1600 HAMPTON ANNEX – DEFERRED MAINTENANCE

PROJECT NO: H27-6107
USC PROJECT NO: CP00394873
JCS PROJECT NO: 12113

ADDENDUM 03
March 7, 2014

ADDENDUM NO. 3

REVISED PLUMBING DEMO PLAN - BASEMENT

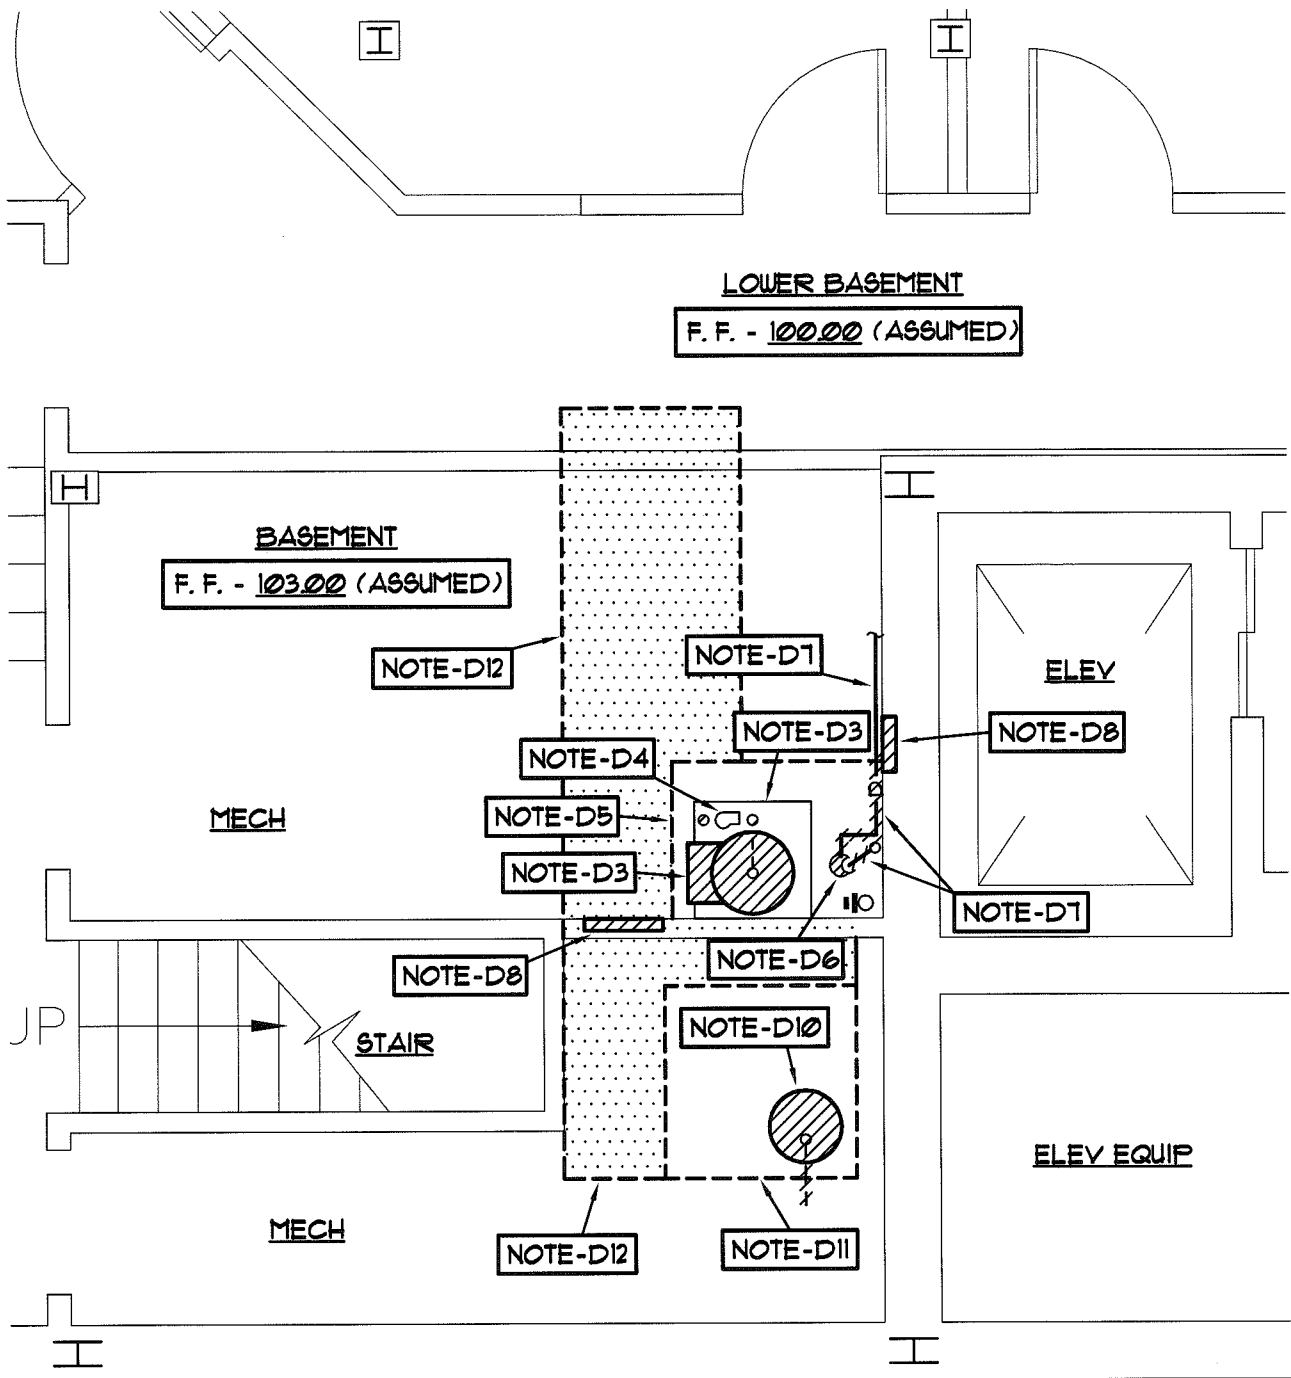
2. Sht P2: - Refer to the attached sketches PSK2 and PSK3 for the installation of the lift station and piping for future work in the basement area. This work shall include increased demolition of floor slabs and the installation of added piping for future connection as shown. Coordinate demolition scope with the general contractor as directed to prevent delays or conflicts with the completion of work that is identified.

D12. PROVIDE SAWCUT AND REMOVAL OF EXISTING FLOOR SLAB THIS APPROXIMATE LOCATION FOR THE INSTALLATION OF 4" WASTE LINE TO SERVE TENANT UPFIT. SEE REVISED PLBG FLOOR PLAN, THIS ADDENDUM FOR LOCATION OF PIPING.

- Contractor is cautioned to provide demolition work as shown and to field verify the exact location and depth for the exist 4" waste line at the immediate start of work.

- Contractor is responsible for field verification of depths related to the existing floor slabs and for the coordination of all information with shop drawings for the lift station basin construction.

- All information related to the existing conditions is required and shall be included on shop drawings prior to ordering lift station. Release of the lift station shall occur after completion of shop drawing review by the Engineer.
-
